MODBAR TECHNICAL BULLETIN
#23
Modbar AV drain box cover

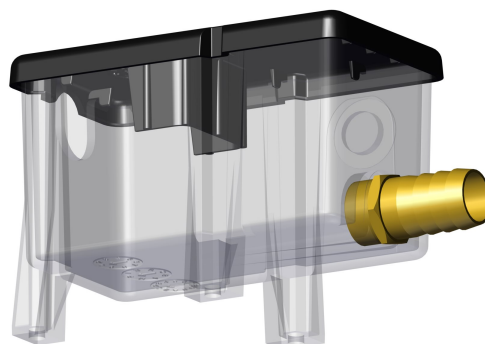
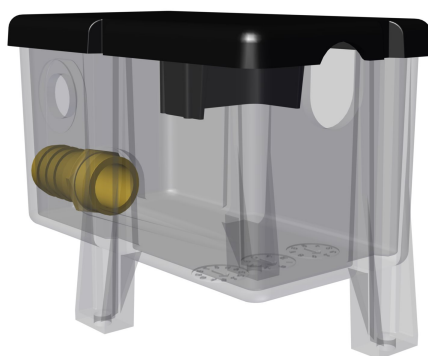
AV modules will now come with a modified drain box cover. The new cover directs the water downwards, reducing the likelihood that water will escape during backflushing of the second tap.

The original part code **F.1.116** will be replaced with part code **F.1.116.01**.

This change will be introduced from serial number **MB001214**. The new cover is completely interchangeable with the original.
